Addendum No.: 3

Date of Addendum: June 2, 2020

Willard Diloreto Parking Garage
Paul Manafort Sr. Drive
New Britain, CT
CF – RC – 402

The following clarifications are applicable to drawings and specifications for the project referenced above.

1 GRID B WALL ELEVATION (LITE WALL)
S104 SCALE: 1/16"=1'-0"

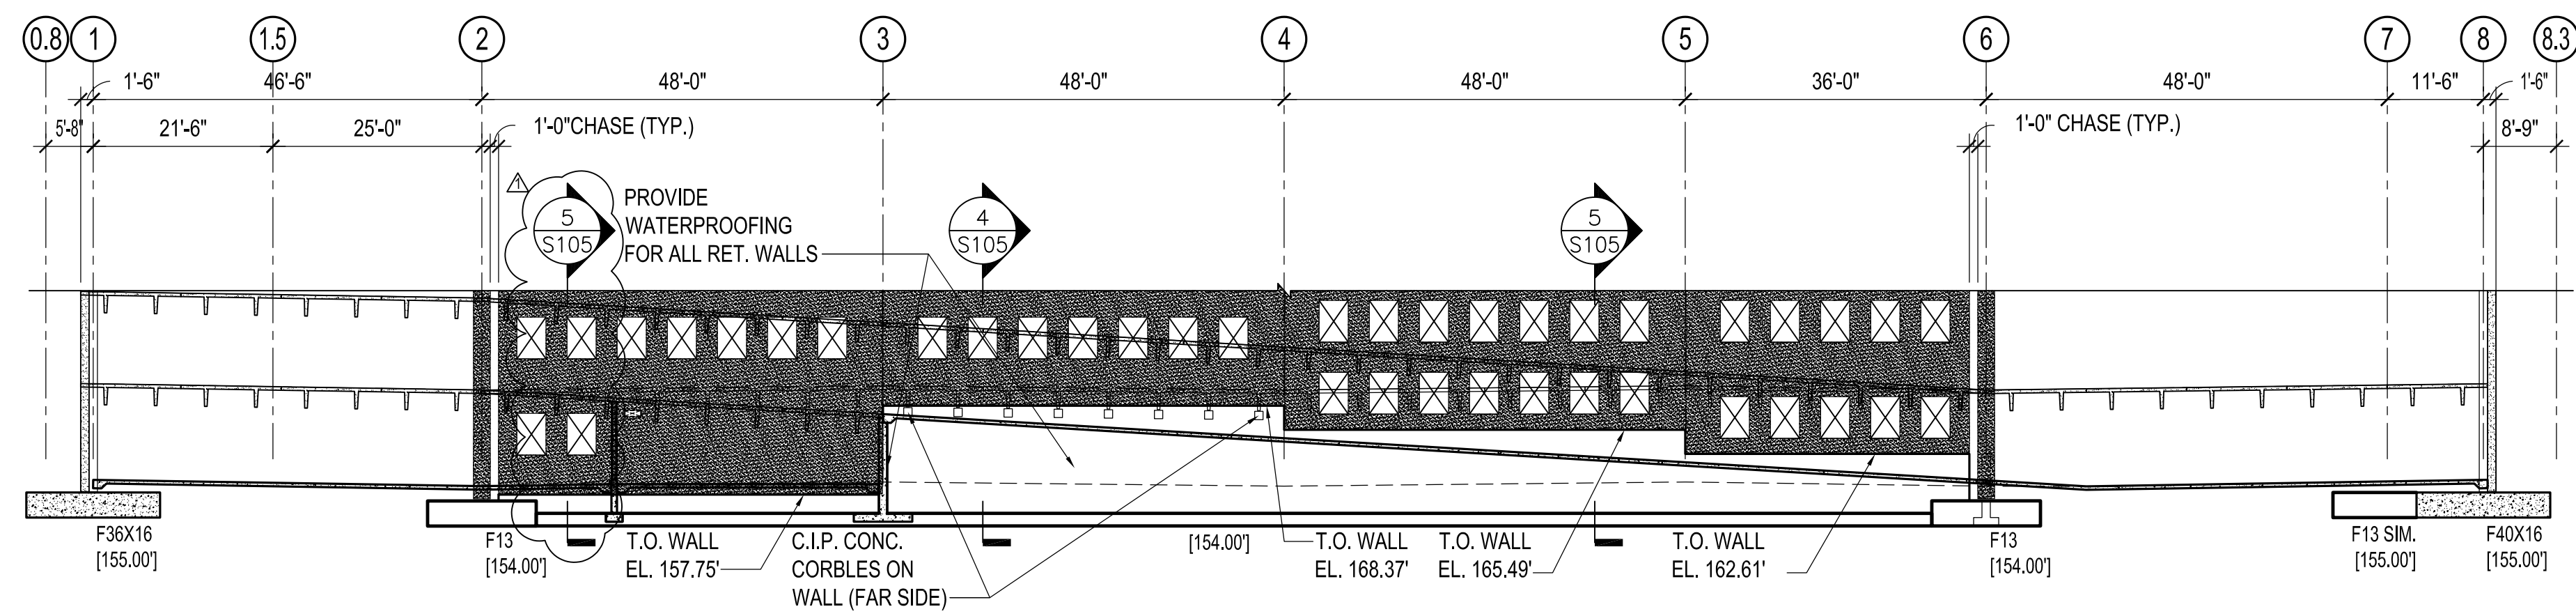
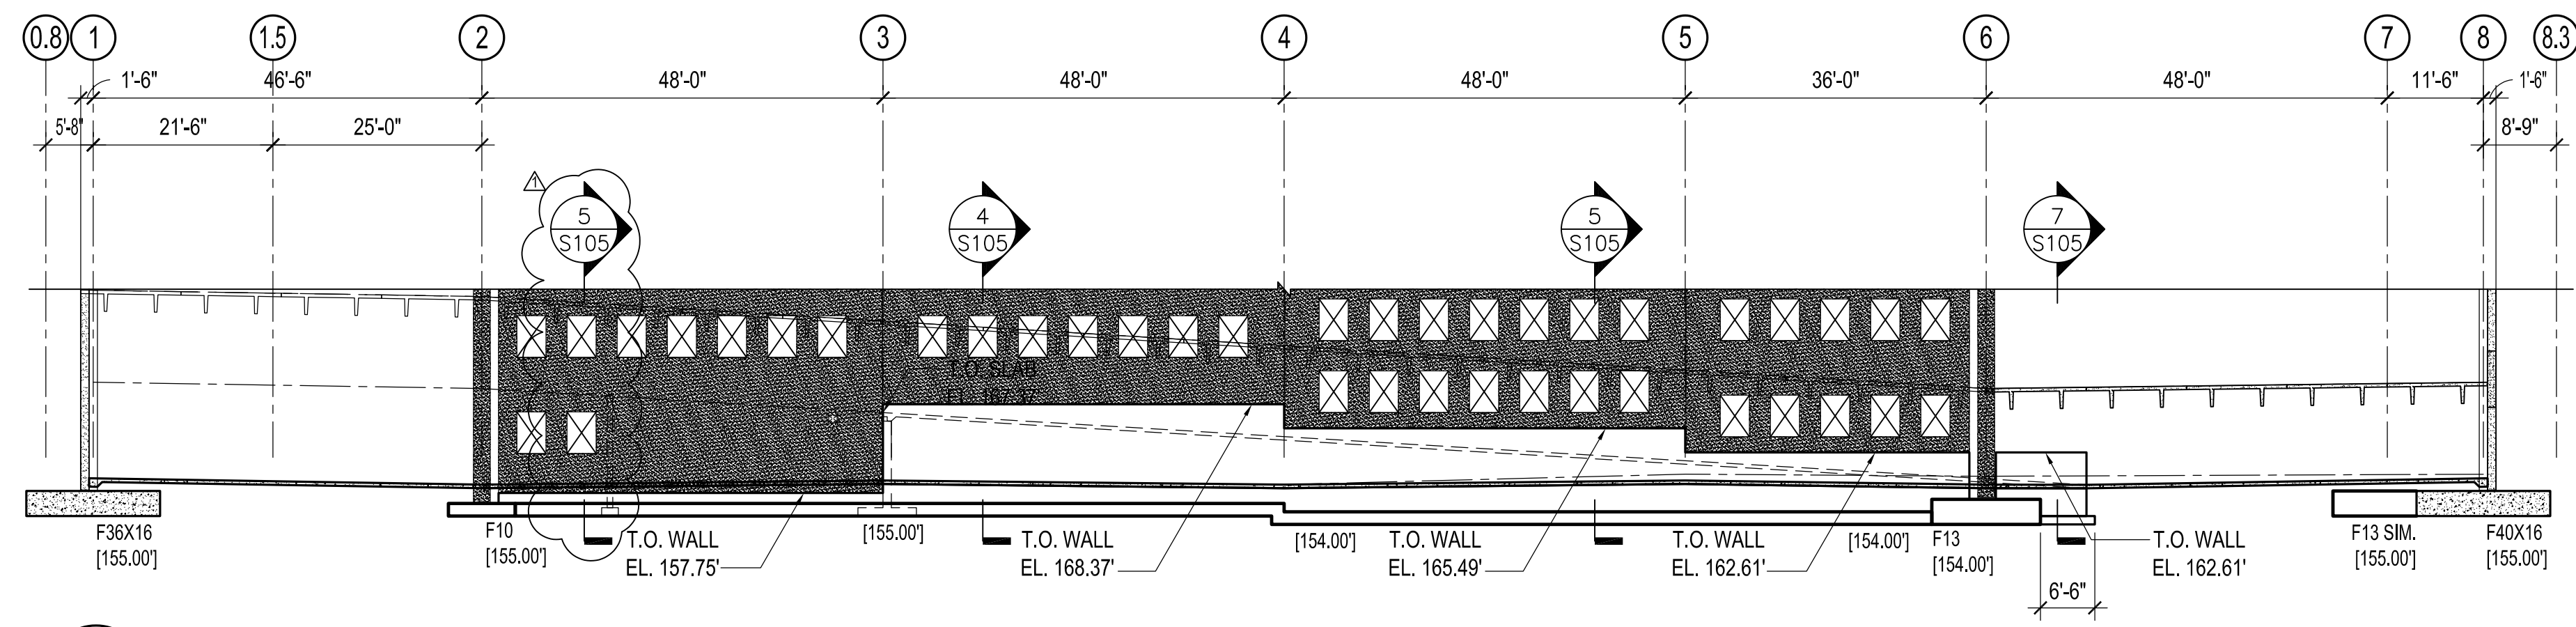
Question: Reference is made to Elevation 1/S104 Grid B Wall Elevation (Lite Wall), Between Col 3 and 4 there is a flag referring to 8 - CIP Conc Corbels on Wall (Far Side). Please indicate where we can find the detail for these?

Answer: See revised drawings #104 and S105. Details 4 and 4A indicate the cast in place corbel and reinforcing details. The section cuts on Elevation 1/S104 indicate the locations of the details.
